## CHANGES FROM SCHEME PERMITTED UNDER ABP-307415-20:

## LISIEUX PARK

## **West Elevations Permitted & Proposed**

PERMITTED WEST ELEVATION (BLOCKS 3&4)

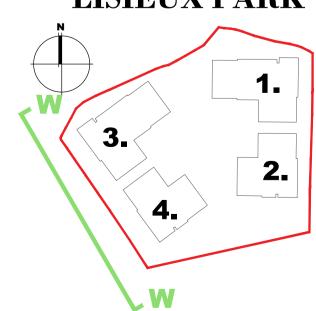
- (1) ALL PERMITTED BEDROOM DOORS
  OPENING ON TO BALCONIES
  CHANGED TO WINDOWS TO IMPROVE
  SAFETY AND SECURITY.
- (2) PERMITTED GLAZED ATRIUM AT ROOF LEVEL (ABOVE STAIR AND LIFT CORE) REMOVED FOR FSC PURPOSES
- (3) GLAZED LINK CORRIDORS BETWEEN BUILDINGS REMOVED
- (4) MINOR CHANGES TO FENESTRATION AT PENTHOUSE LEVEL TO TALLY WITH PERMITTED FLOOR LAYOUTS
- (5) NON-STRUCTURAL COLUMNS
  OMITTED FROM BALCONIES TO
  IMPROVE DAYLIGHT INTO
  APARTMENTS
